Reply

Orientation Control System: Enhancing Aerial Maneuvers for Quadruped Robots

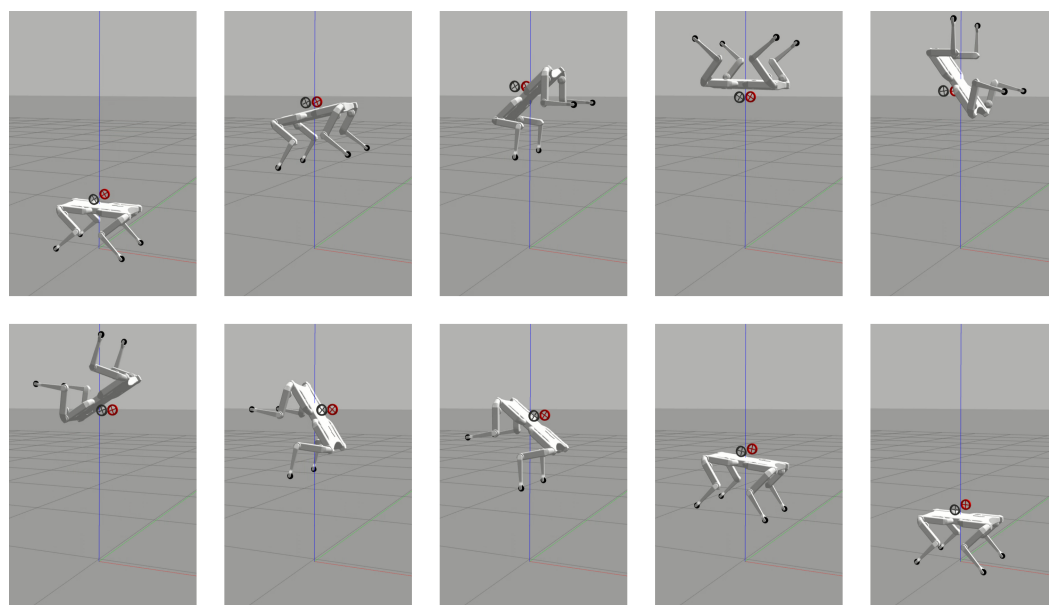
- **Comment 1:** 'All the simulations are performed in Gazebo'. The paper must have more details related with the simulation, including a snapshot of the simulated robot in its environment.

Response: Thank you for the insightful comment. We summarized the details of the simulation in Table 1, which is incorporated to the manuscript too. Moreover, inspired by your suggestion, we attached a sequence of snapshots for the third simulation (back-flip), showing the robot in the Gazebo environment (Fig. 1)
